## **DEVELOPMENT REVIEW COMMITTEE (DRC) COMMENT REPORT**

**PROJECT NAME:** Lauderdale Yacht Club

**CASE NUMBER:** R18056

**REQUEST:** Site Plan Level III Review: Conditional Use;  
Yacht Club and Associated Parking Reduction

RIO VISTA ISLES  
DETAIL #03  
SCALE: 1" = 10'

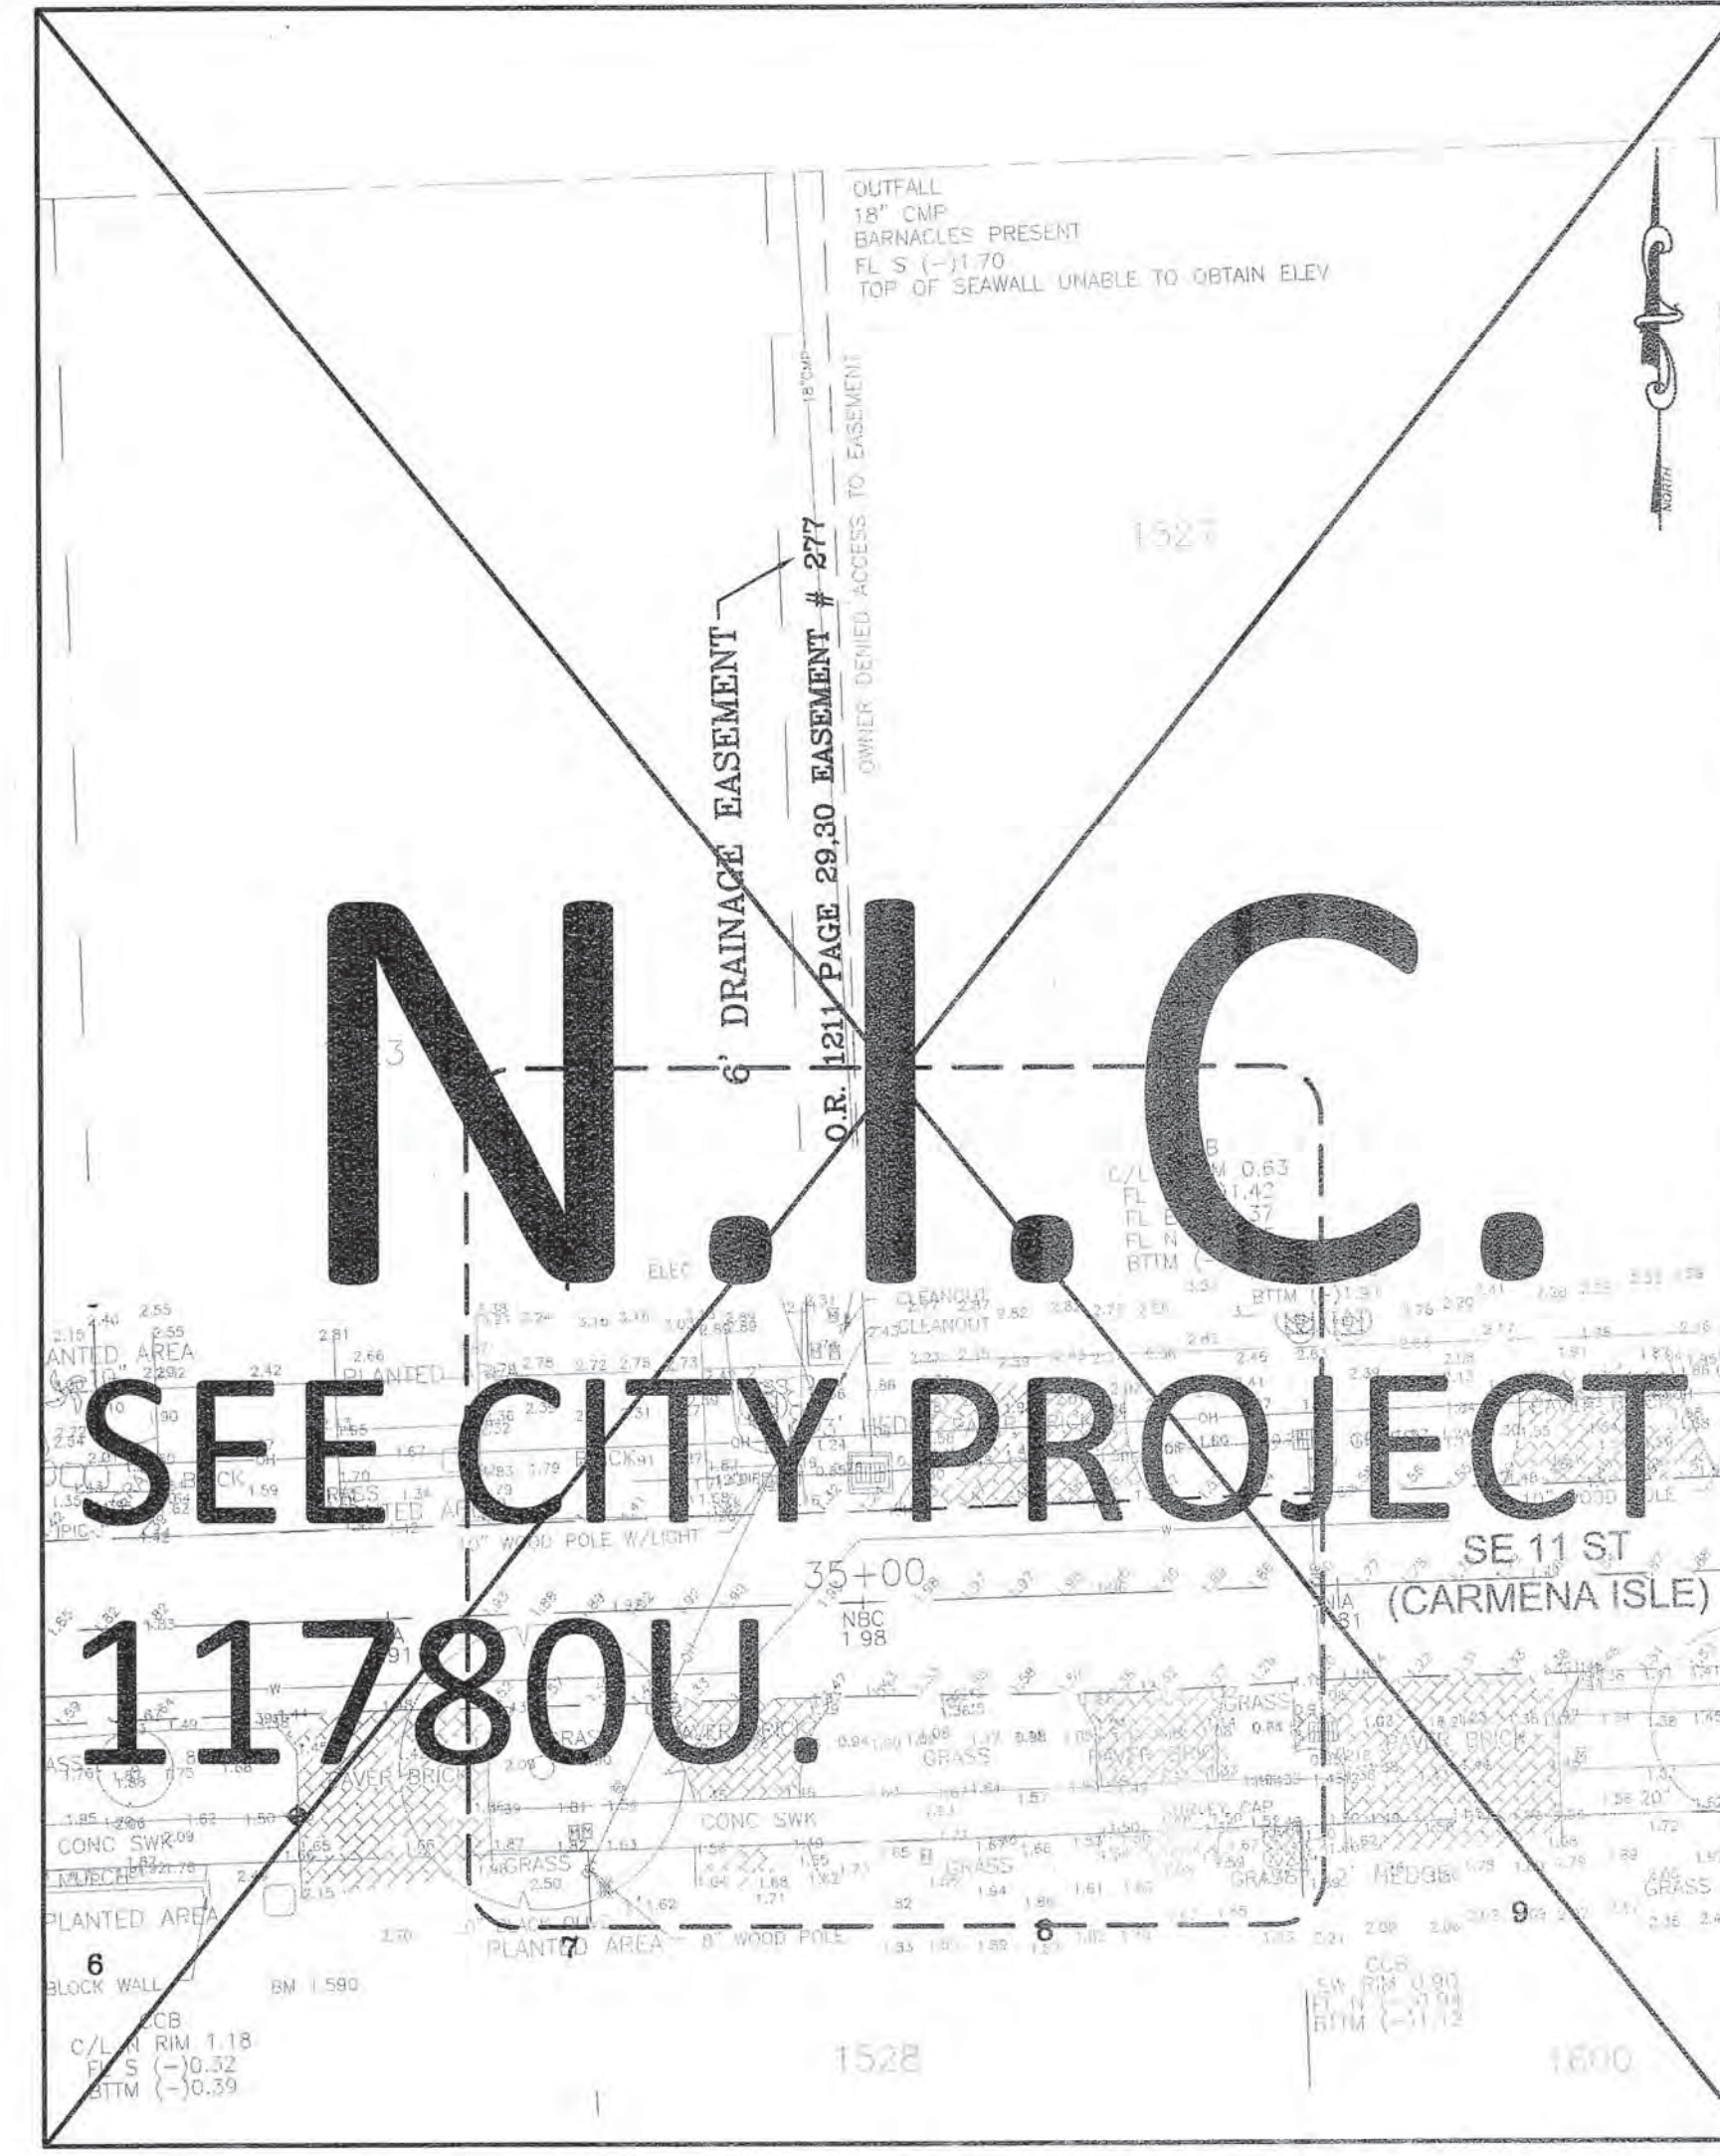
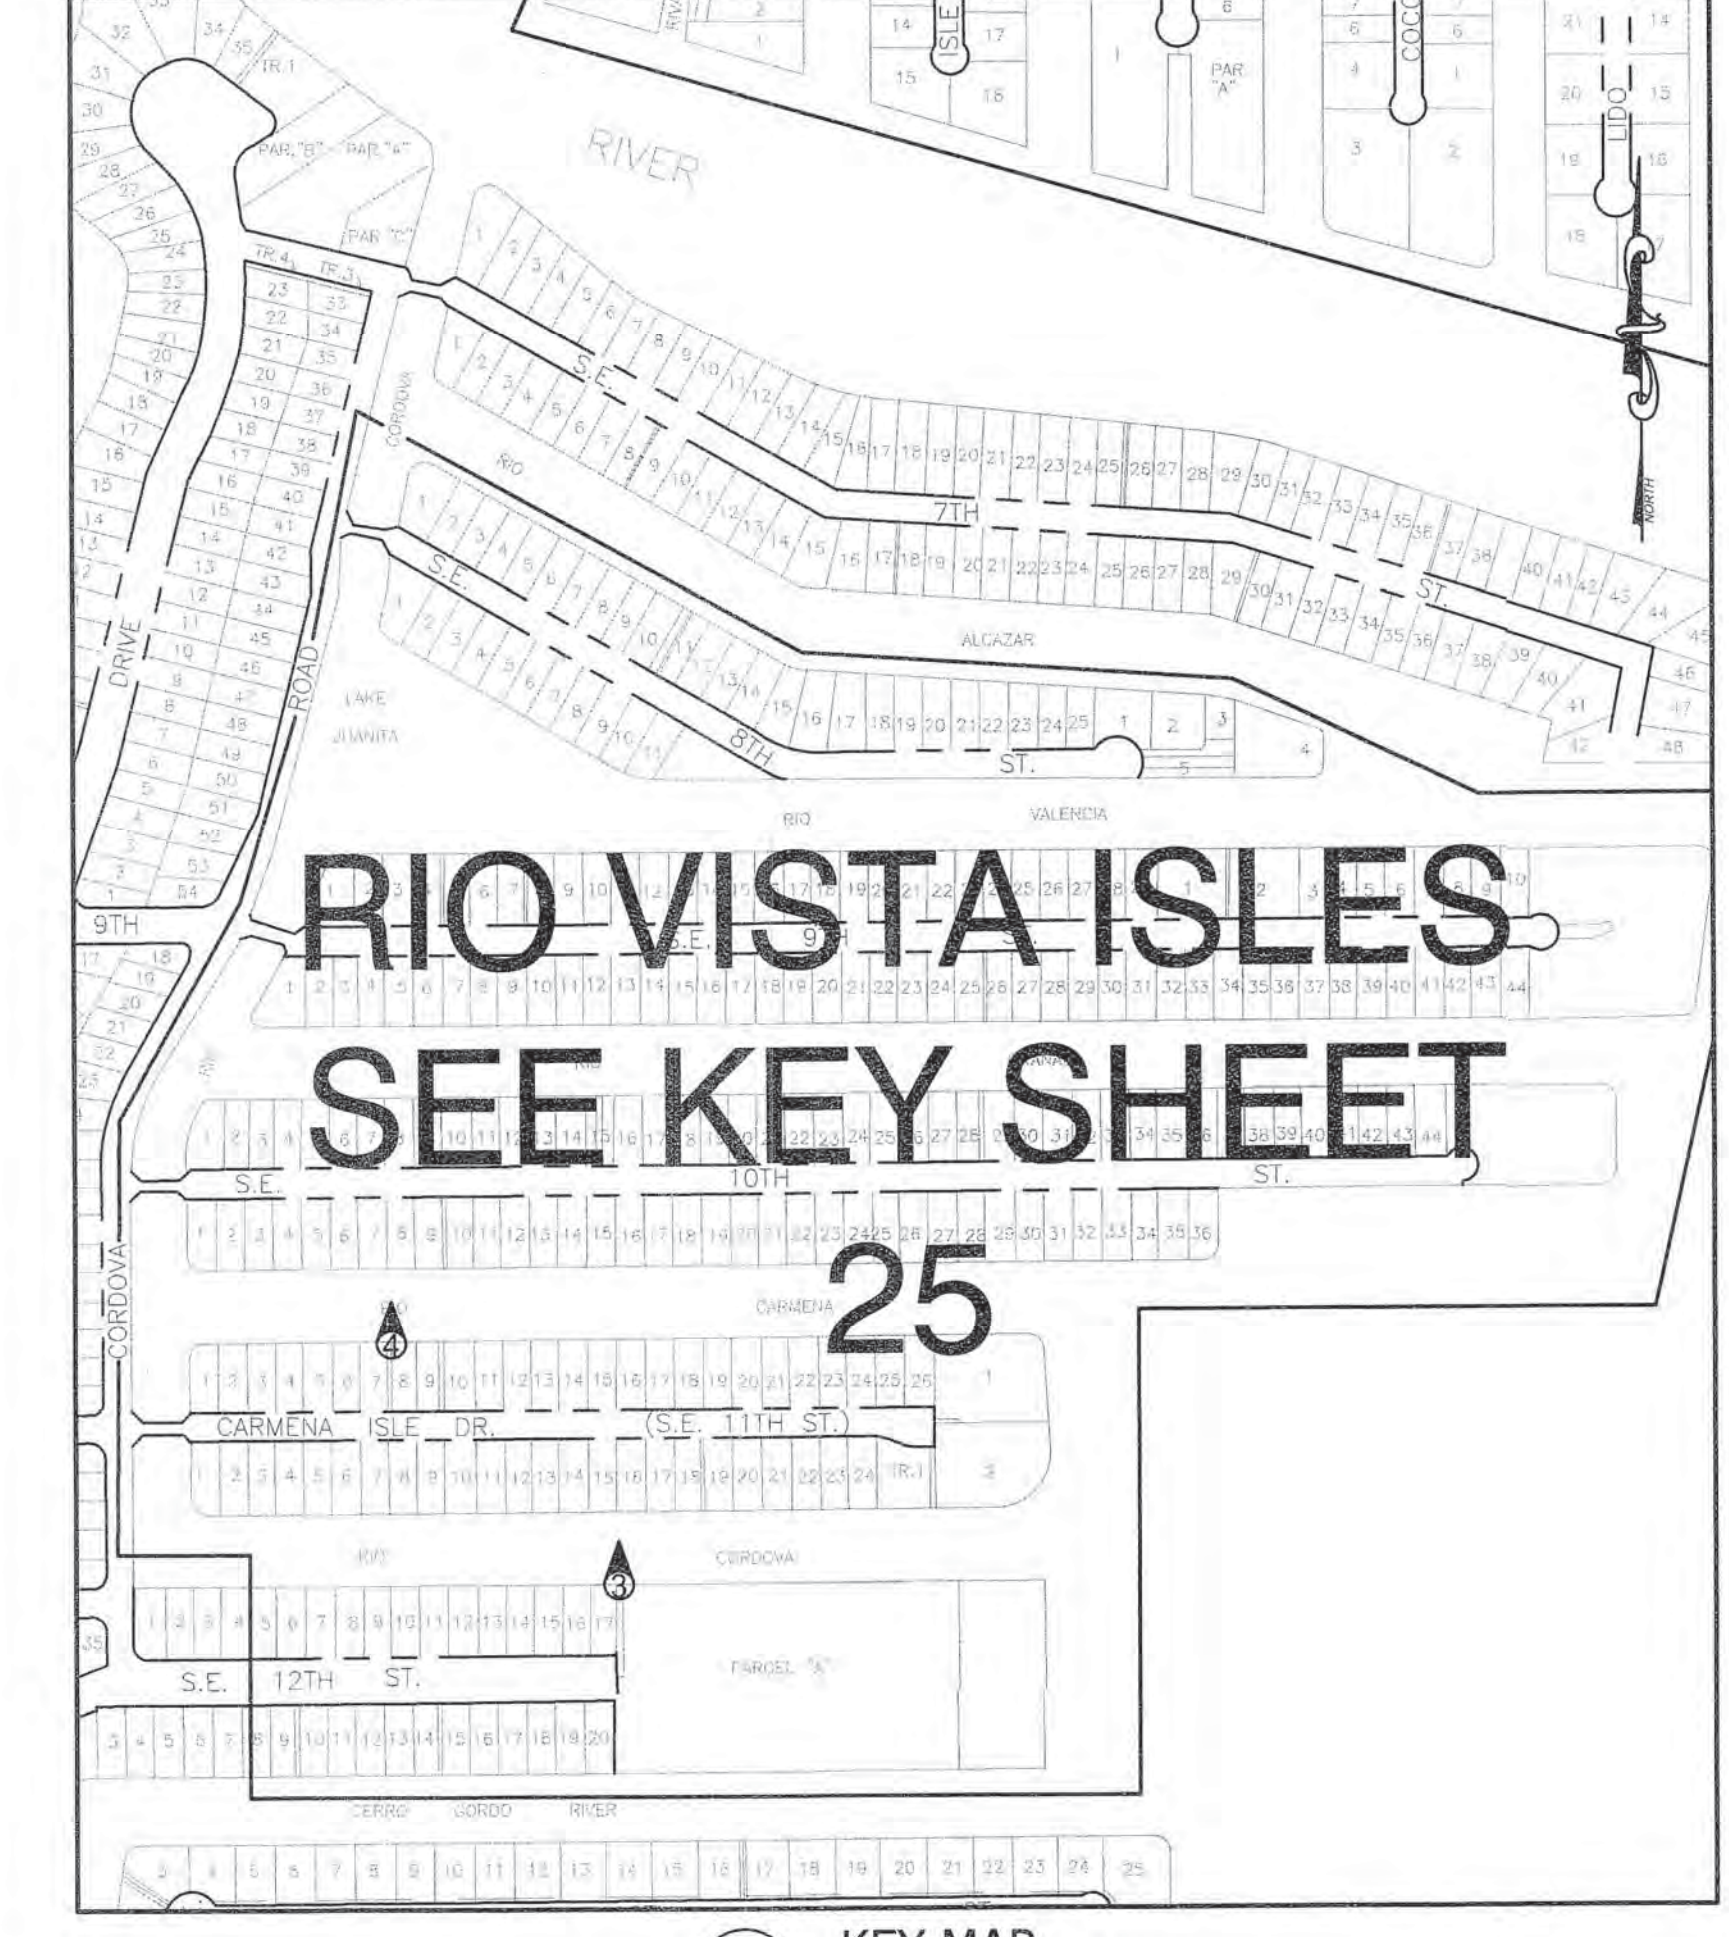
The City owns and maintains stormwater infrastructure adjacent to the proposed development as shown with green line work in the map provided at the end of this report and asbuilt plan. The following comments pertain to possible impacts of the proposed development and/or construction activities to the existing condition of the City's stormwater assets. The applicant shall provide an itemized response letter addressing the following comments:

3. There is an existing 15" City stormwater drainage outfall and a drainage catch basin on SE 12 St at the north side of the guardhouse. The existing building(s) that are currently over the drainage pipe that are proposed to be renovated require the relocation of the drainage easement and the public drainage outfall pipe. Engineer of record shall proposed City DSD Engineering staff possible solutions to rectify the conflict(s), so Public Works Stormwater Operations and Engineering divisions can review.

- a) Contractor shall provide CCTV videotapes to City STW OPS of the existing stormwater system to the limits shown with green line work in the storm map provided at the end of this report in order to document the PRE and POST construction conditions of the City's storm system.
- b) Contractor shall provide the PRE construction CCTV to City STW OPS when applying for a demolition permit at the City's building department.
